**CITY OF ISANTI
PLANNING COMMISSION MEETING
TUESDAY, March 15, 2022
Immediately following 7:00pm City Council Meeting
CITY HALL**

MEMORANDUM

SUBJECT: Site Plan Review for two proposed Industrial buildings located at 687 and 703 E Dual Blvd NE

Date: March 8, 2022
To: Stephanie Hillesheim, Community Development Director
From: Jason W Cook, P.E.
City Engineer
Subject: Wolf River Electric – Site Plan Review
City of Isanti, MN
Project No.: 0R1.126218

CONCRETE VALLEY GUTTER		BMI DETAIL PLATE NO: 7-100	APPROVAL:	DATE:	DETAIL LOG	
PATH: Y:\7-100			STDS	COMM.	SPRING,2006	REVISIONS:
ORIG. PROJ:			REMARKS:		DATE:	
PROJ. #:			ENG/TECH:

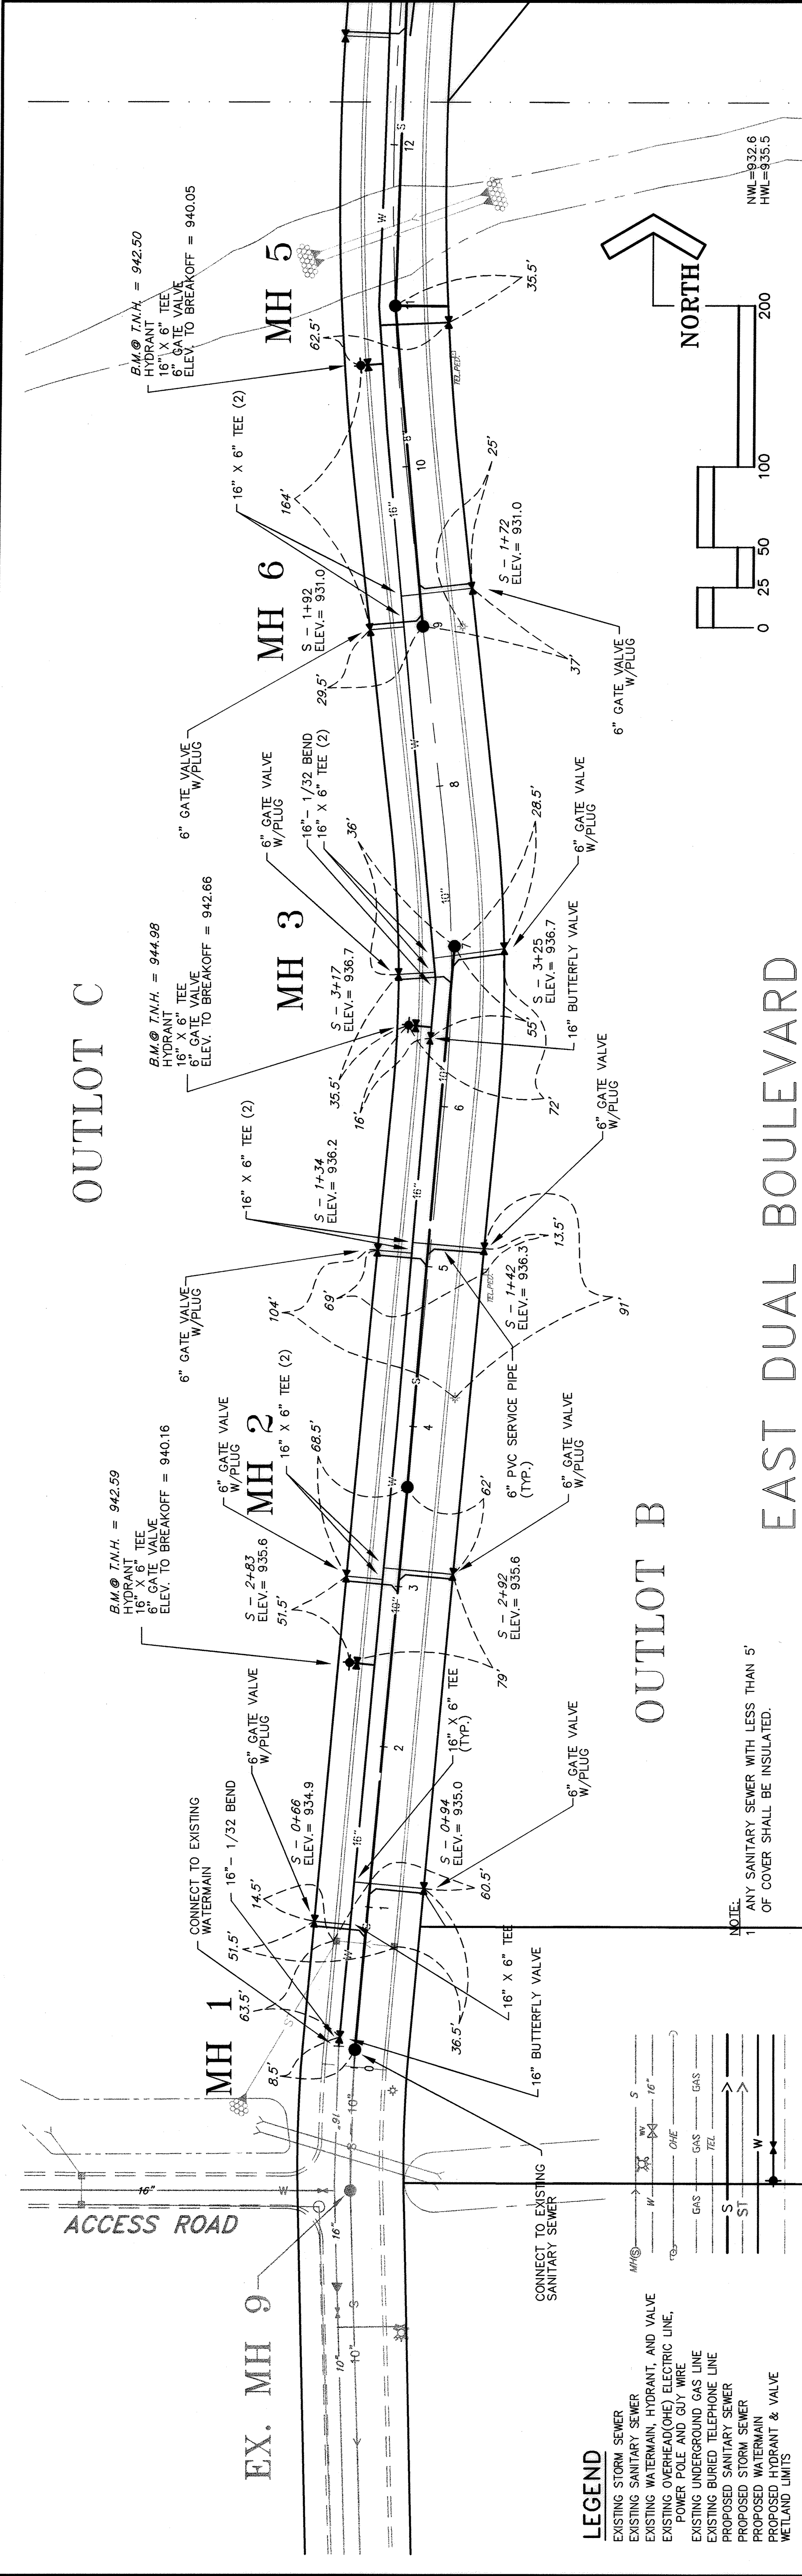
1. Sheet C3 Civil Site Plan:
 - a. Western parking stall too short, car would be hit.
 - b. Construct valley gutter through both proposed entrances. See attached detail.

CONCRETE VALLEY GUTTER		BMI DETAIL PLATE NO: 7-100	APPROVAL: STDS COMM. SPRING, 2006	DATE: REVISIONS:	DETAIL LOG
PATH: Y:\7-100		REMARKS:			
ORIG. PROJ:					
PROJ. #:		ENG/TECH:

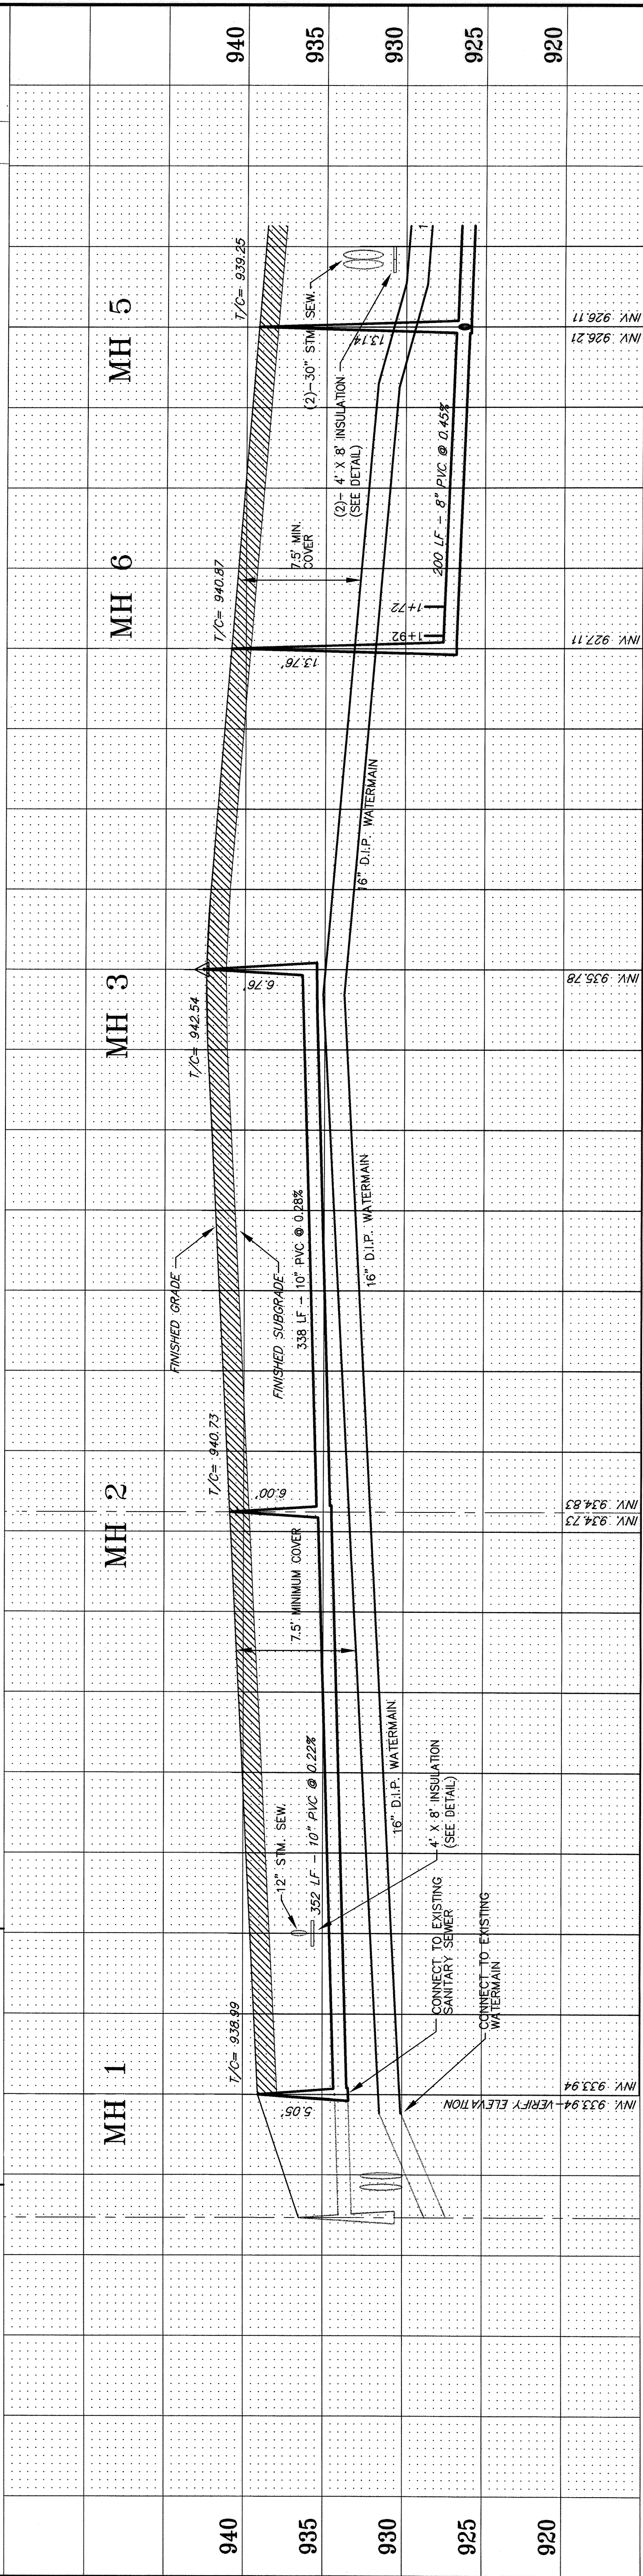
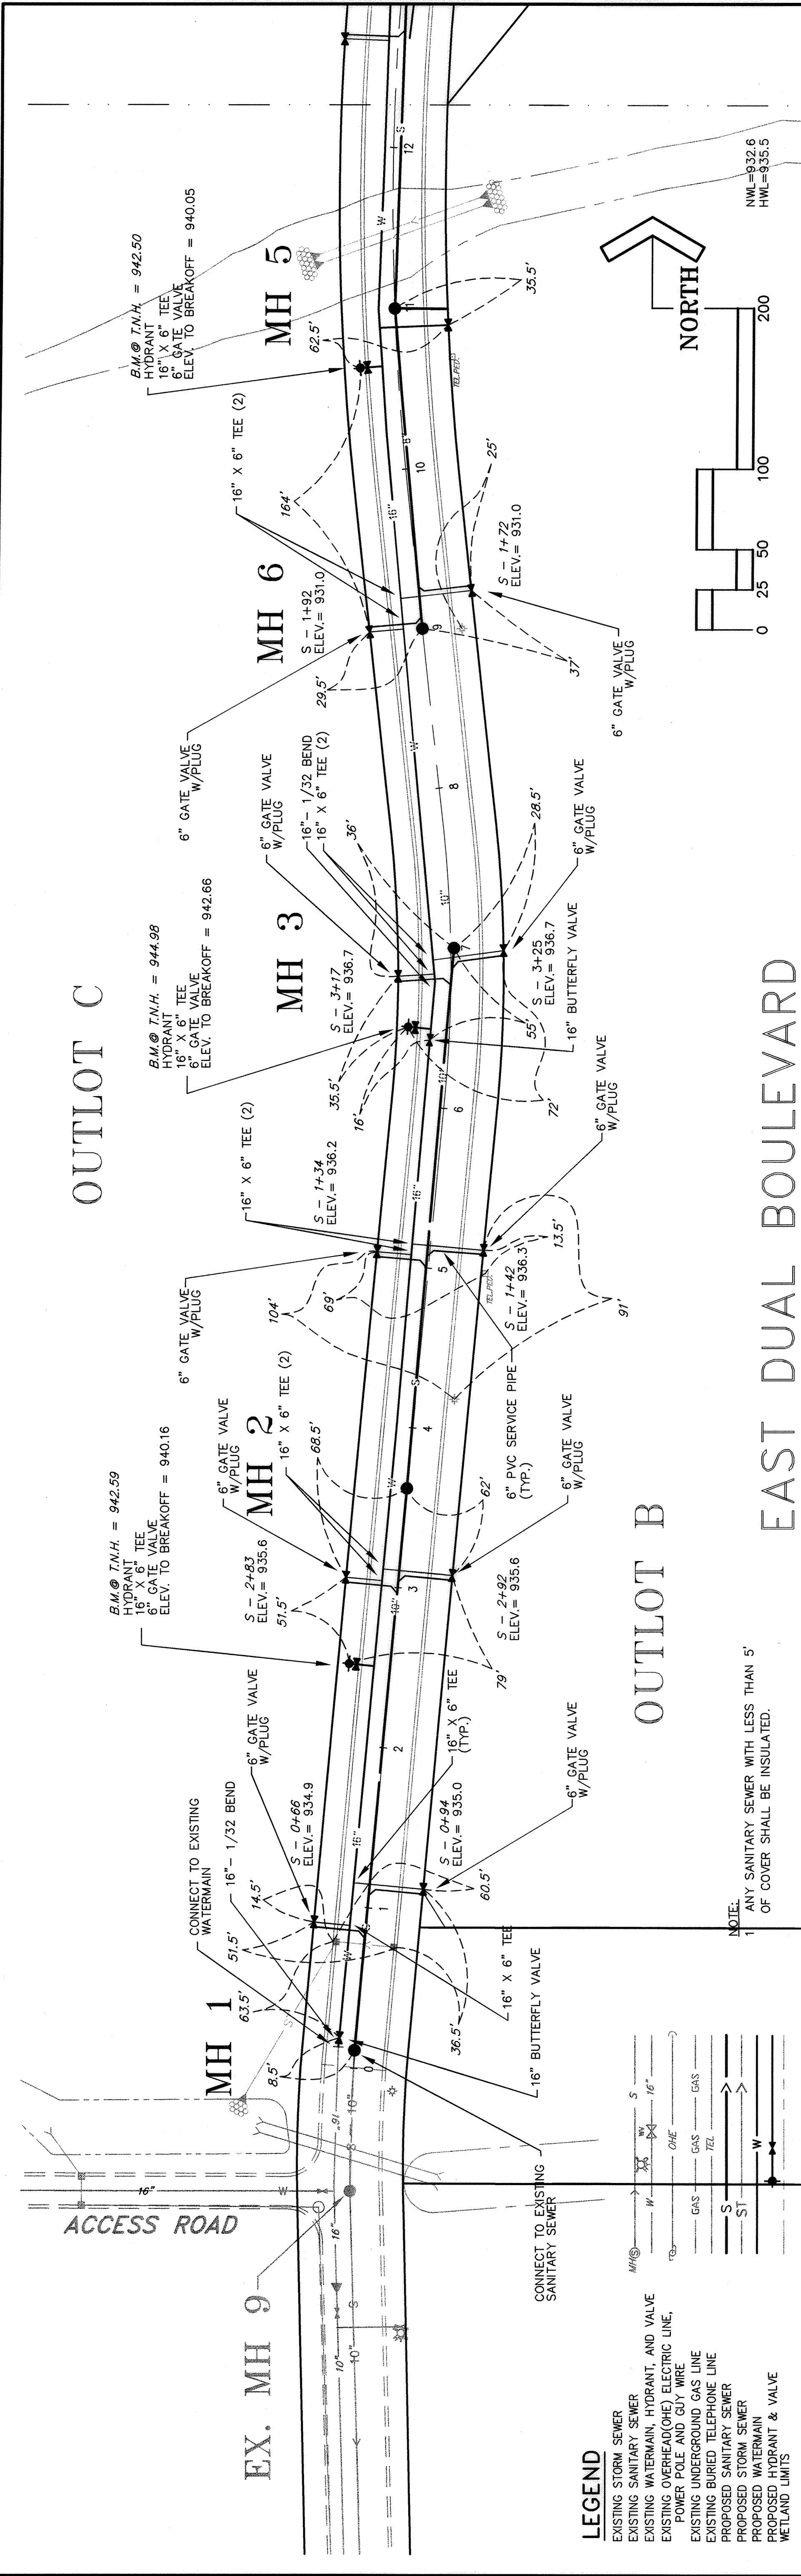
1. Sheet C3 Civil Site Plan:
 - a. Construct valley gutter through both proposed entrances. See attached detail.
 - b. Need a 15’ ingress/egress easement from Lot 1.
